Response to Referee's comments

Reviewer #1

Reviewer #2

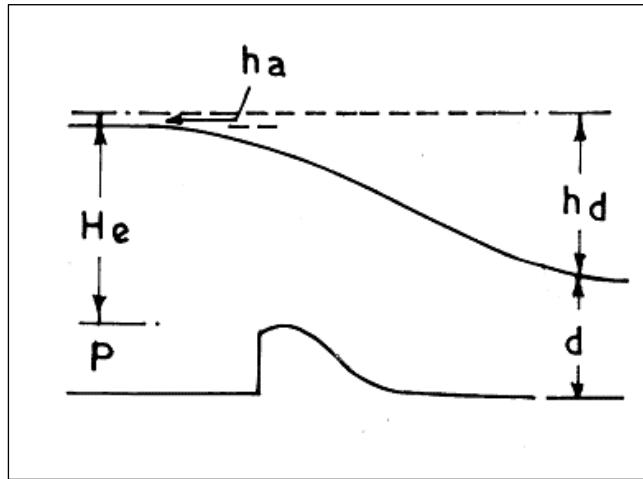
6. It is also important to look into backwater effects which might occur downstream of the dam site effectively reducing the flow capacity of the spillway and river crosssection involved. The current work does not convince that there has been enough focus on those local effects which however become crucial when looking into dam reliability. And again, there is no information regarding the actual dam structure which

The effect due to interference caused by the downstream apron, in terms of variation of (Ca/C), the ratio of modified coefficient to free discharge coefficient,

with respect to apron effect, has been studied in terms of variation of the parameter $(h_d+d)/H_e$. where These parameters are shown in the following figure.

RE: The Red Hill dam, spillways and reservoir features were indicated in tables 1, 2 and 3 in the manuscript. The dam Spillways are ogee type which the discharge characteristics spillway can be derived from the characteristics of the spillway including the coefficient of discharge, the head of water on the spillway crest and the width of the spillway.

The values of the coefficient of discharge is influenced by a number of factors such as (1) the relation of the actual crest shape to the ideal nappe shape, (2) the depth of approach, (3) the inclination of the upstream face, (4) the contraction caused by the crest piers and abutment, (5) the interference due to downstream apron, and (6) *the submergence of the crest due to downstream water level*, which have been studied and well documented by USBR.

It was found that when this parameter exceeds about 1.7, the downstream floor has practically no effect on the discharge coefficient (Khatsuria, 2015)¹.

The effect of submergence of crest by Tail Water (TW) on discharge coefficient is studied in terms of parameter (h_d/H_e) , also called degree of submergence. It was reported that the coefficient of discharge begins to be influenced by the submergence when the degree of submergence (expressed as the depth of TW above the crest/head on crest) exceeds about 40% (Khatsuria, 2015).

According to the design and operation data, no record was found to show that TW above the crest/head on crest exceeds about 40%. Therefore, for the Red Hill dam, there is no downstream effect on spillways discharge capacity. A description was added to the section 2 of the manuscript, briefly.
